**Service Bulletin**

**No. : MZ05-003**

**Model:** SA-11S1

**Subject:** Software Update

## 5. SERVICE MODE

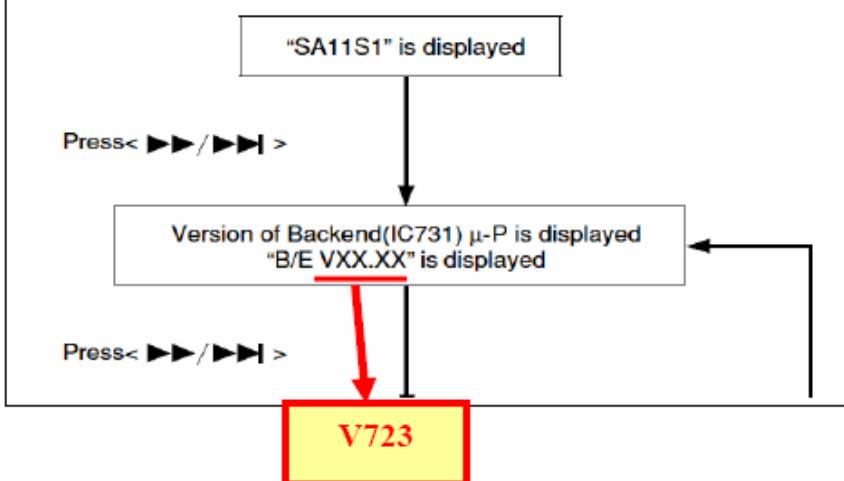
**Symptom:** When playing back the Discs specified, the unit will display incorrect SACD TEXT and does not display TEXT by Track play.

**Solution:** Update the firmware version to V723

### How to upgrade (IC731) by upgrade DISC.

1. Press the **POWER** button while pressing the **PLAY** and **STOP** buttons.
2. Press the **OPEN/CLOSE** button to open the tray, Insert the update DVD-ROM (part No.:90M-SA11S1DVD).
3. Press the **SOUND MODE** and **STOP** buttons.  
The Display indicates "VERSION UP".
4. Press the **OPEN/CLOSE** button to close the tray.  
The Display indicates " TOC Reading" >>> " FILE CHECK">>>> " ERASE">>>> " WRITING".
5. Software updating will be done automatically.  
When the updating is finished, The disc tray opens automatically.  
(Updating takes about 1 minute.)
6. Remove the DVD-ROM from the disc tray.
